Z-40
(2017)

Rezoning Plat
1143 Terrell Mill Road
 Cobb County, Georgia
 Land Lot 937, 17th District, 2nd Section

ZONING COMMENTS:

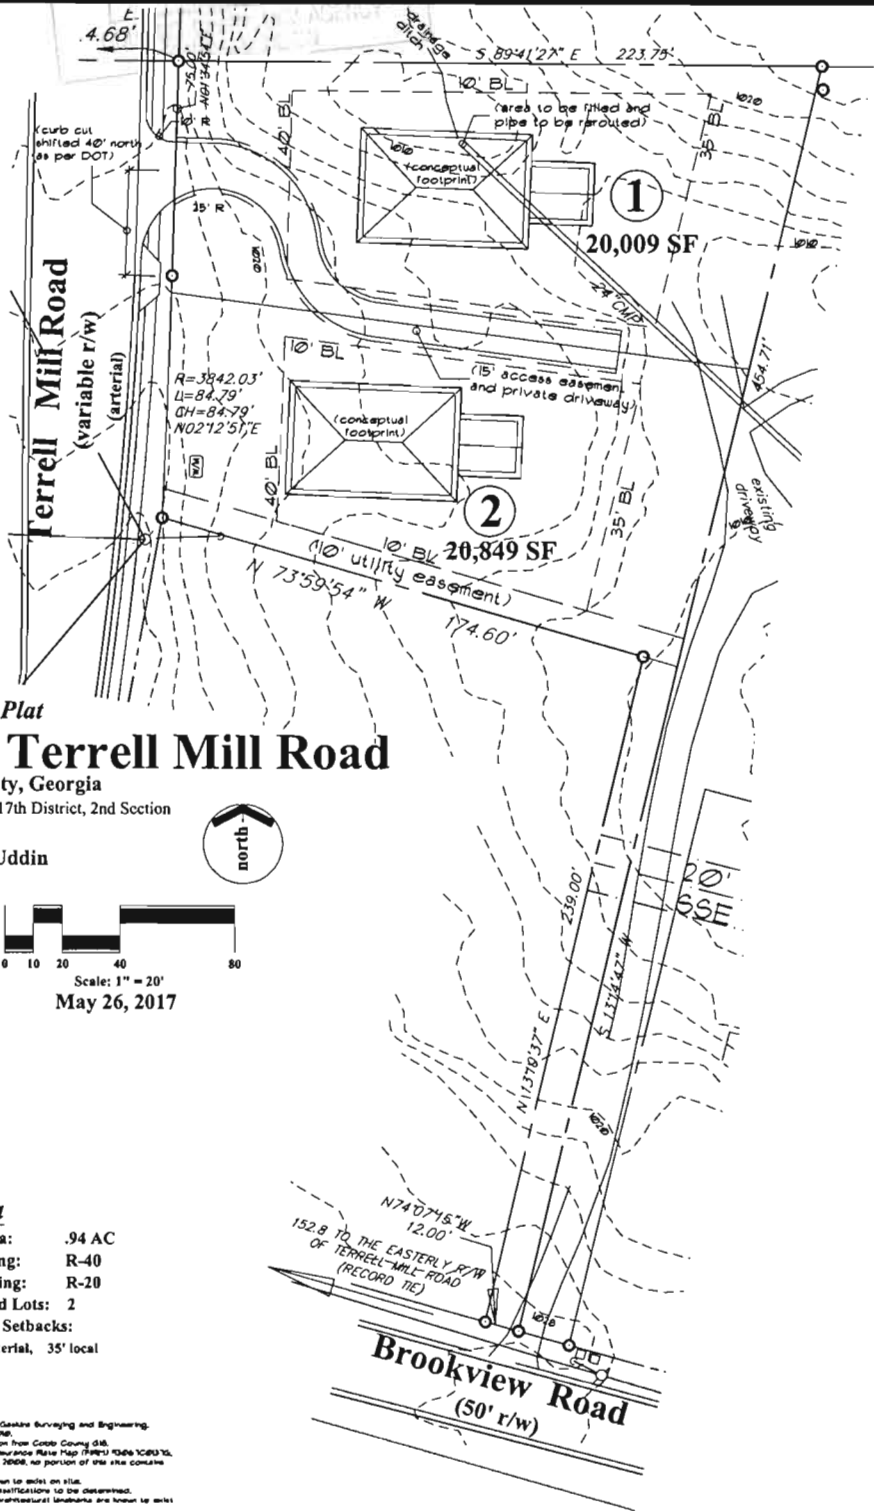
Additional Comments: To use on-site manhole, non-standard-width private sewer easement necessary

1. There is a fairly significant drainage area that flows through this parcel that includes two discharge points from the DOT R/W. The applicant must provide adequate conveyance of all offsite drainage through the site. This may require an agreement from the existing downstream neighbor to replace the existing inadequately sized private storm pipe.
2. A site grading and drainage plan will be required to be approved by Stormwater Management.

Recommend removing and closing driveway apron along Terrell Mill Road frontage that development renders unnecessary.

Recommend shared driveway be a minimum of 250' from the intersection of Terrell Mill and Brookview Road.

Recommend a no access easement on Brookview Road.

1. Revised site plan received by the Zoning Division on June 28, 2017, with the District Commissioner approving minor modifications;
2. Department of Transportation comments and recommendations;
3. Site Plan Review comments and recommendations;
4. Stormwater Management comments and recommendations
